Permit Type Building/Residential/Addition/SFD Permit Number B23004799 Opened Date 12/10/2023
 Description of Work SFD/ CONSTRUCT 18 X 24 (1)STORY ADDITION FOR FAMILY ROOM/; 1 STORY, Full Basement. 0R, 0FB, 0HB, 0FP, OTHER STRUCTURE = None, 0BR, PORCH/DECK = Optional Deck, ENERGY METHOD = N/A.

Herboldt Residence

Proposed Addition to the

Onsite Sewage Disposal System Design Plan

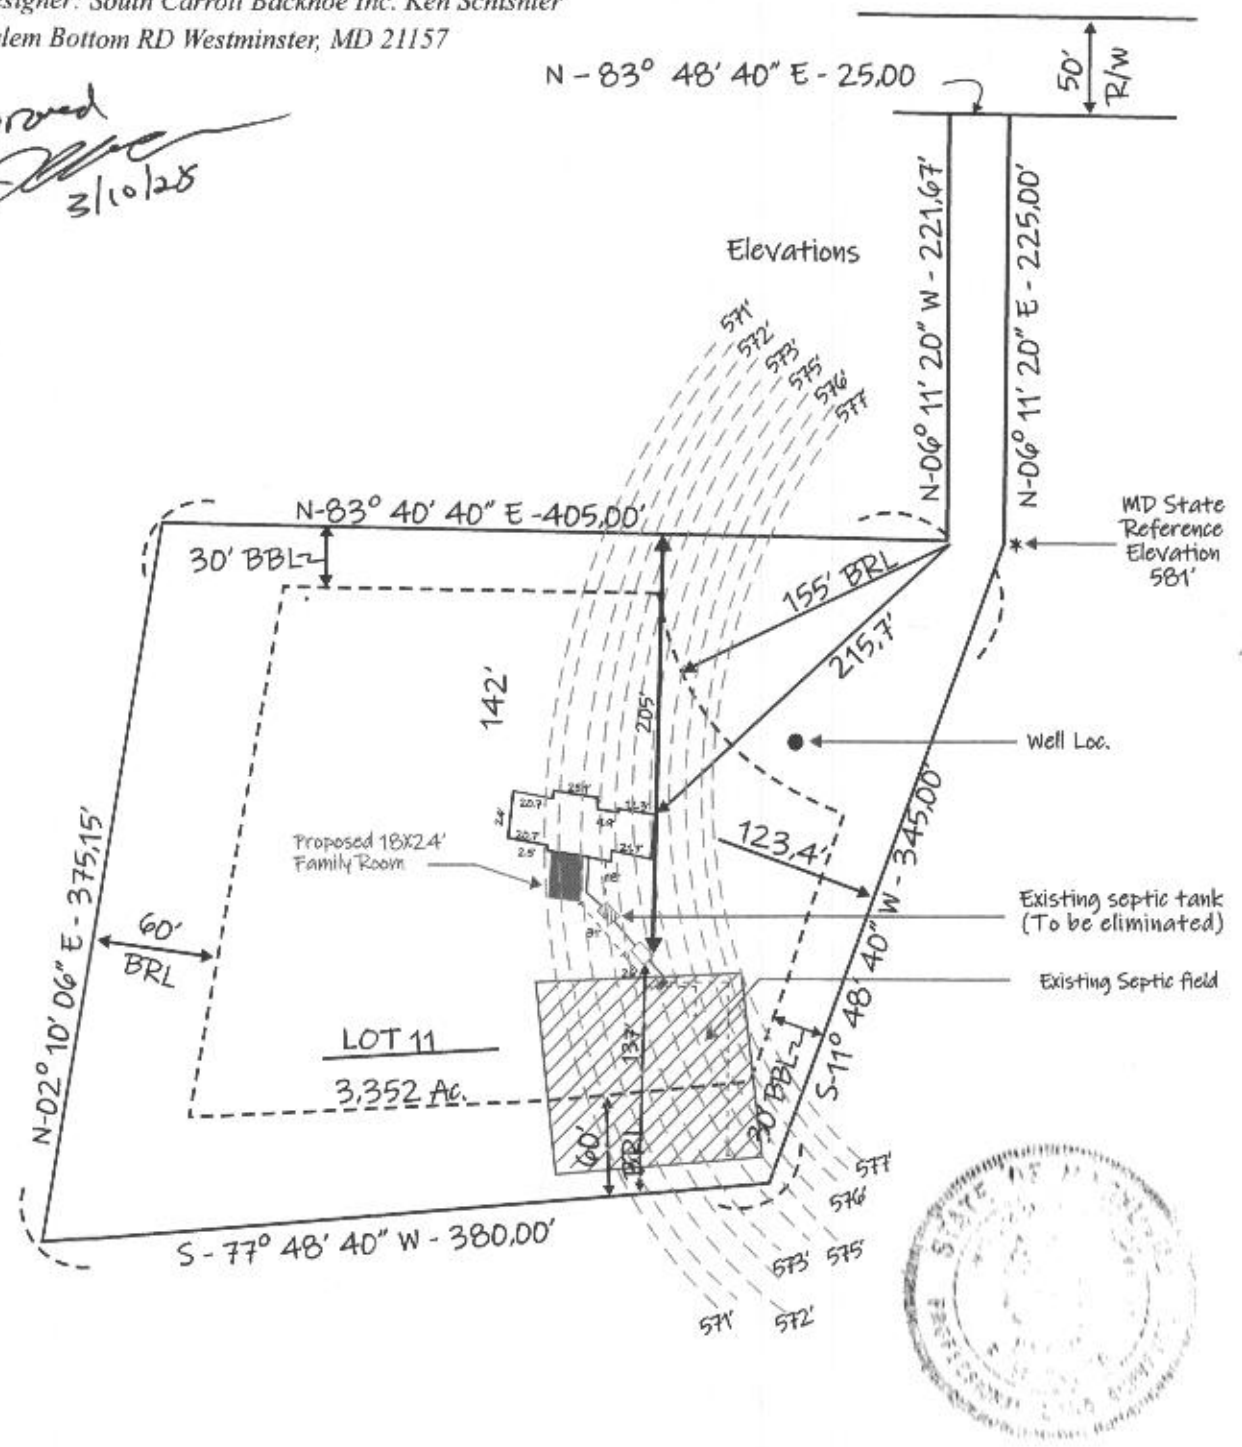
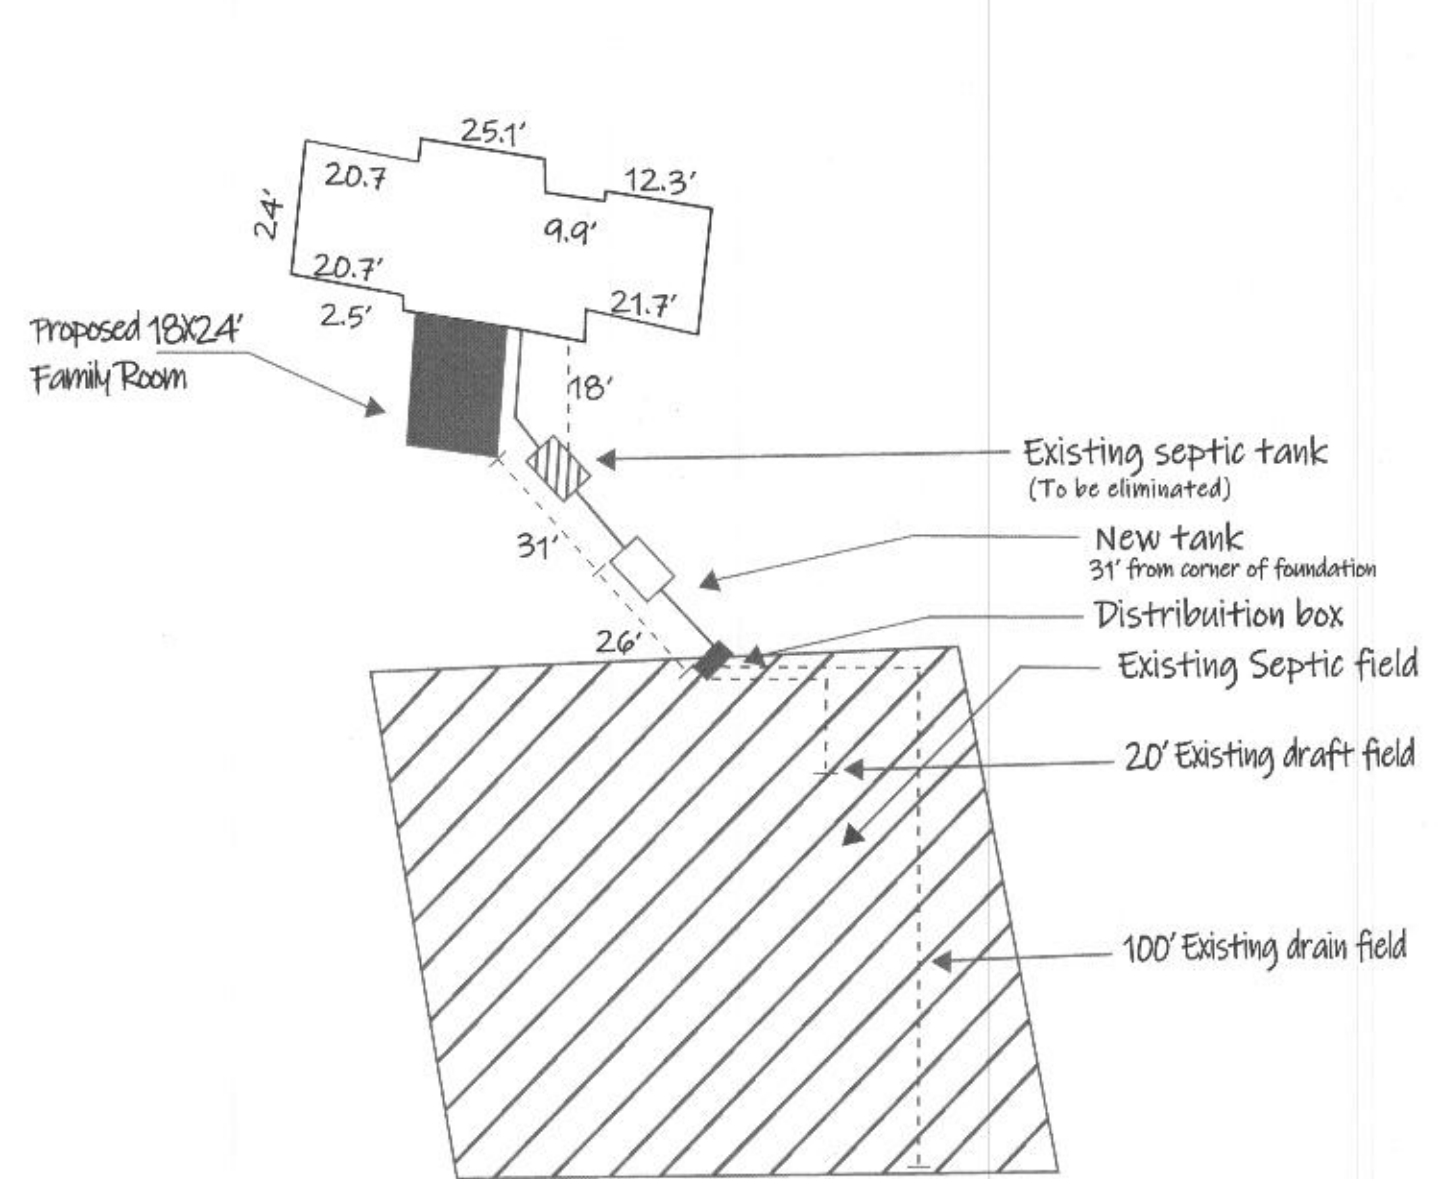
The topo lines can come from county GIS, which show 2' lines with elevations above sea level. The other items you mention can be shown on the plan. Remember that the plan designer must be a licensed onsite wastewater professional from the state board. We frequently see Babylon tanks, the designer can just put the tank details on the plan or make it an attachment.

#1 I understand what you say about the 14' depth requirement but we know for sure the trenches were recorded at 13' . Is that not really close enough since we know our existing septic system meets requirements and is functioning fantastic, or do we really need to do a test trench next to the existing trenches to show that extra foot?

#3 The topography lines in the area of the tank and drain field. Do they need to be shown just in the drain field? Do we need elevations (above sea level) or can we list reference heights in relation to top footing height of home, basement floor height, sewer pipe height leaving the basement, sewer pipe height entering the existing tank, sewer height exiting the tank, fall per foot exiting the tank on the main run heading to the drain field?
We intend to list all of this information on the existing Plat drawing showing the home, driveway, well location, foundation size and location, old tank location, new tank location 30 from new addition foundation and drain field.

In looking at the file, I do see the plan establishing your area and I do see the perc notes. While the notes are not quite as detailed as we would like, they do have just enough info to know the depths at which the suitable soil starts and ends. I think they are acceptable to confirm the existing sewage disposal area. As for the existing system, I do have the septic permit and as-built drawing from the installation. The trenches are not equal length, which is not how we would install them today, but otherwise they seem to be constructed according to current standards. The permit states it was installed for 3 bedrooms. The tank is sized for 3, but a calculation of the trench sizing using our current sizing formula has them adequate for 4 bedrooms. The one issue is that the trenches were installed to 10' depth while the perc tests stopped at 13' depth. Current regulation requires 4' of suitable soil beneath a trench bottom.

The last point is regarding the tank replacement. A 2000 gallon tank is more than enough size for the proposed use. It is true that we cannot issue a septic permit to a contractor without having an approved design plan on file. That is why Melanie could not give the contractor anything when he came to the office. As we discussed, that is a requirement instituted by MDE in 2023 to the local health departments.

We cannot issue a septic permit for the tank replacement without first getting a design plan to approve. The contractor can attempt to produce one or you can hire a surveyor/engineer company that has worked with our office to produce one. The OSDS plan guidance fact sheet from our website is attached. For a tank replacement only, we need a plan showing the proposed location with 2' topography contour lines shown. It must show the sewer profile with the depth of the existing sewer lines and the proposed tank. It must also have a cross section of the tank from the tank manufacturer. The critical piece for your property will be the depths. It looks like the ground elevation is a little uphill at the trenches from where the sewer line leaves the house. The trench inlets are listed as 4.5' below grade. The plan preparer will need to know the field verified elevation of the sewer line where it leaves the house and where the tank is being proposed. They should be able to do that by checking the depths of the line leaving the house and the depth of the current tank. This is important here because the line needs to have at least 1% fall and the maximum tank depth is 3' to the lid. That will be tight in this case. We've had tank replacements in the past where assumptions were made about depths and during installation they were found to be wrong and the tank could not be installed as planned. The purpose of the detailed plan is to avoid those problems.

To sum up, in order to issue a septic permit, we need the design plan as described above. While the new tank is installed, we will need the contractor to dig a test hole near the trenches to 14'. If the soil is good and once we approve the septic permit, we can sign off on the building permit. This is also assuming the answers to the bedroom questions above. Let me know those answers and if you have any questions. Thanks

SITE INSPECTION SHEET

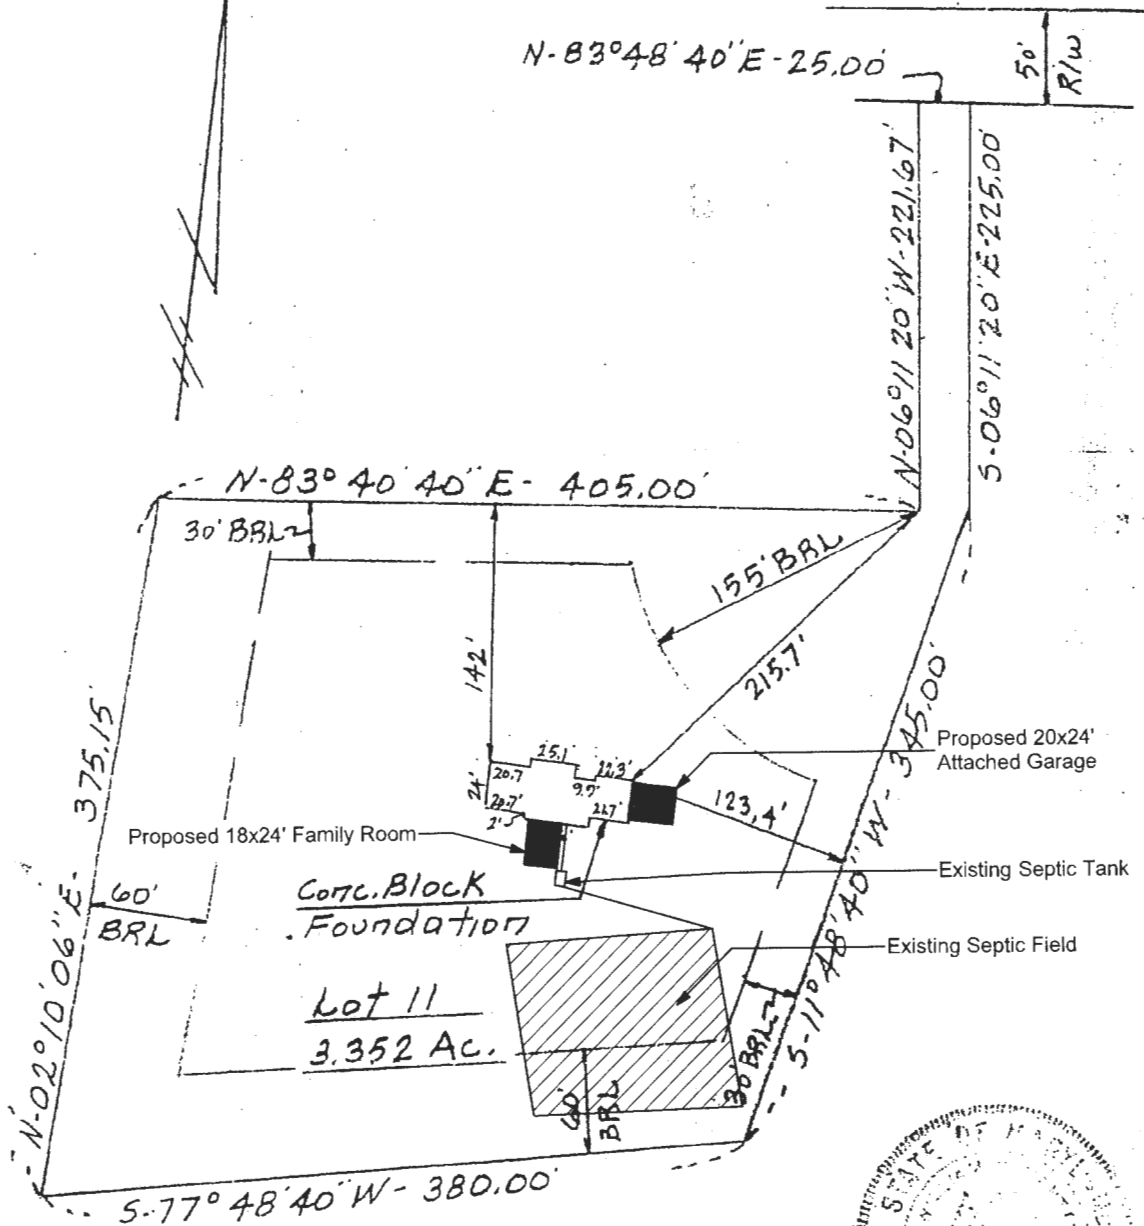
COMMENTS: Well Missing Corrodit well need repaired.
Tank will need to be replaced in advance of
SP approval. Down gradient well at 1030
Sunset Valley
